**HISTORIC PRESERVATION REVIEW BOARD
STAFF REPORT AND RECOMMENDATION**

Property Address: **915 F Street NW** () Agenda
Landmark/District: **Equitable Co-Operative Building Association (Interior Landmark)** () Consent Calendar
() Denial Calendar
Meeting Date: **April 4, 2013** () Concept Review
H.P.A. Number: **#13-027** () Alteration
Staff Reviewer: **Brendan Meyer** () New Construction
() Demolition
() Subdivision

Figure 1 Rear addition at 915 F Street NW clad in glass and Cor-ten™ weathering steel

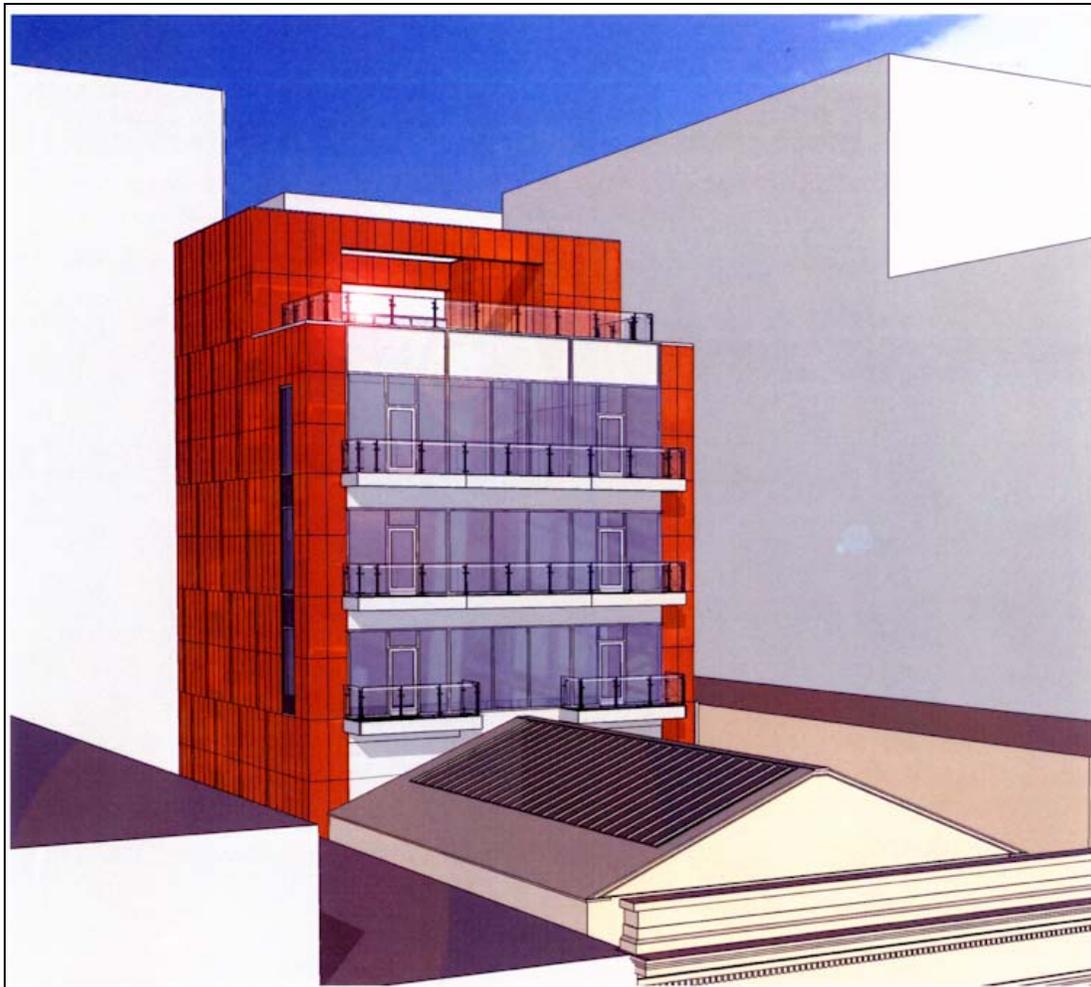
The applicant has selected a metal and glass cladding scheme for all elevations of the addition. The selected metal is a panelized weathering steel product called cor-ten that will install as unfinished steel but in 2-3 years oxidize to a stable layer of rust that acts as a barrier against destructive corrosion (Figure 1).

The proportions and geometries ascribed to the front façade of the addition are not a primary concern to the evaluation of compatibility of the addition. Although, introducing some depth where the cor-ten meets the curtain wall, by pushing back the curtain wall minimally and creating a reveal of cor-ten, would recreate an *in antis* pier-column relationship like that in the historic bank façade and the landmark Old Masonic Temple at 901 F Street NW.

Cor-ten is an ambitious material choice for an addition to a historic landmark, but is currently popular with contemporary designers. A notable recent use of it was to clad the Barclays Center basketball arena in Brooklyn, New York.¹ A smaller local example that has only started to weather was recently constructed at 705 6th Street NW, but was not reviewed by the Board because it is not in a historic district. One technical criticism of the material that should be considered at 915 F Street is that as water runs off the material an orange oxidation stain can spread to surrounding materials and

surfaces like concrete and glass.¹ In that respect, wind-borne water coming off the cor-ten and landing on the historic banking hall skylight—one of the most character defining features visible from the landmark interior—could be stained by spots of rust.

HPO has encouraged the designers to mitigate the introduction of a tower addition behind the small scale buildings of F Street by designing the material to blend into its background. Whether that means to replicate the rear or front of a building that is in the distance behind 915 F Street, those materials were traditionally masonry brick, stone or stucco and occasionally terra cotta. A characteristic of masonry is that as it is seen from farther away, any jointwork becomes less pronounced. That is opposite of the effect of the pronounced seams in the cor-ten, effectively making the addition appear closer to the viewer than it actually stands. For as much as the cor-ten sections will be visible above 915 F Street, selection of a different material is recommended.

The HPO recommends that the Board direct the applicant to revise the elevation materials to an alternative, preferably masonry material, and delegate final approval to staff.

Figure 2. Proposed view from F Street NW showing existing taller buildings on either side of the proposed addition.

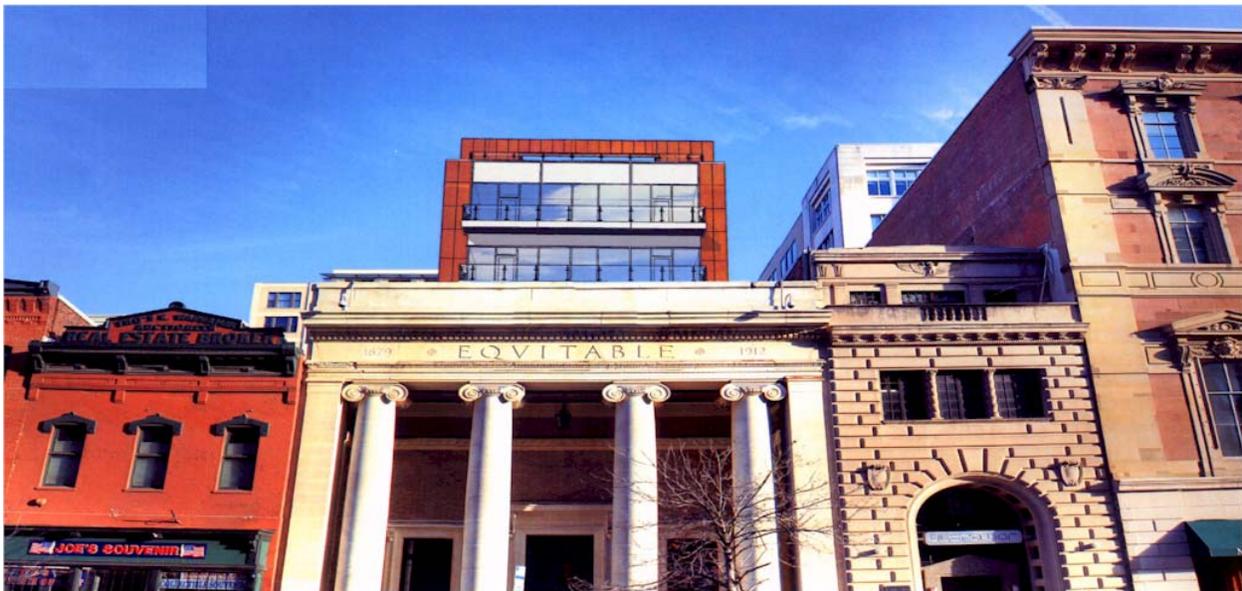
The height of the addition, including penthouse, has been reduced from 105 feet to 98 feet above alley level. It would be set back 69 feet from the façade, preserving the existing skylight that is integral to the integrity of the historically designated banking hall (Figure 2).
